Re: Re-subdivision – Nottingham Hills Lots 19 & 21

To: Gary A. Goeschel II, Director of Planning
From: Victor Benni, P.E., Town Engineer 
Date: August 12, 2020
Re: 22 & 24 Upper Kensington Drive – Nottingham Hills
Subdivision Application Review

TITLE OF PLAN:	Conservation Design Development Nottingham Hills Subdivision; 4 lot Re-subdivision of Lots 19 and 21
DATE RECEIVED:	March 2020
DATE DISTRIBUTED:	May 2020
REVIEW DEADLINE:	July 7, 2020

TYPICAL HAY BALE INSTALLATION

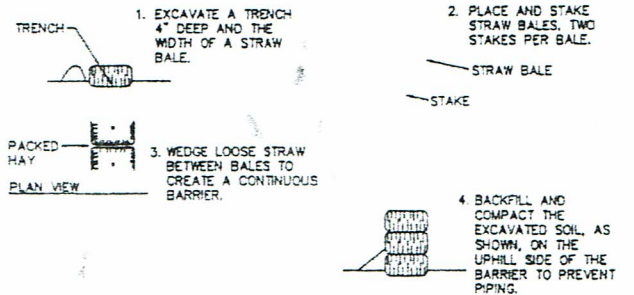
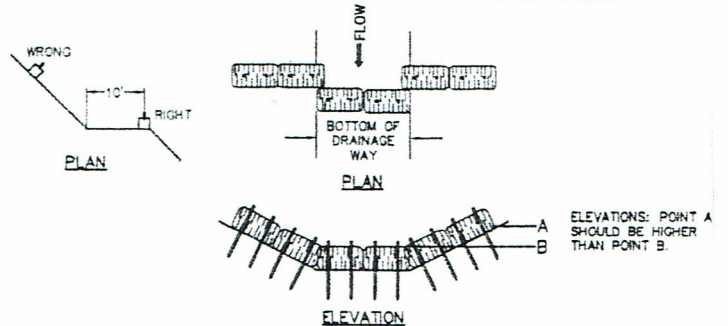
See attached Ex. 1 which will be added to a new page (Page 5 of 5) to this applications plans.

10. ALL ROAD SECTION EMBANKMENTS, EITHER CUT OR FILL, SHOULD BE STABILIZED AT THE TOE OF THE SLOPE BY STAKED HAYBALES OR SILT FENCE.
11. SWALES AND DIVERSION STRUCTURES SHOULD HAVE HAY BALES PLACED ACROSS THEM EVERY 100' IN ACCORDANCE WITH THE DETAIL BELOW.

EROSION & SEDIMENT CONTROL NARRATIVE

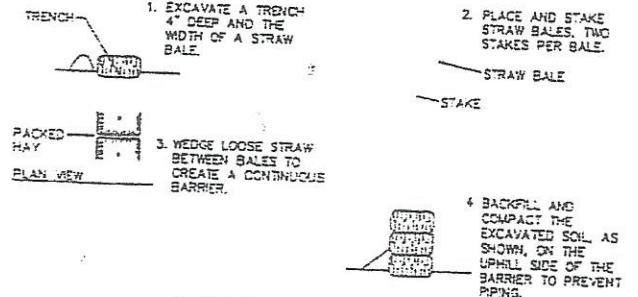
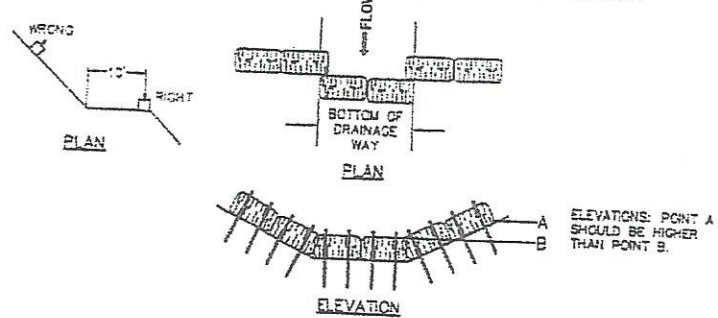
10. ALL ROAD SECTION EMBANKMENTS, EITHER CUT OR FILL, SHOULD BE STABILIZED AT THE TOE OF THE SLOPE BY STAKED HAYBALES OR SILT FENCE.
11. SWALES AND DIVERSION STRUCTURES SHOULD HAVE HAY BALES PLACED ACROSS THEM EVERY 100' IN ACCORDANCE WITH THE DETAIL BELOW.
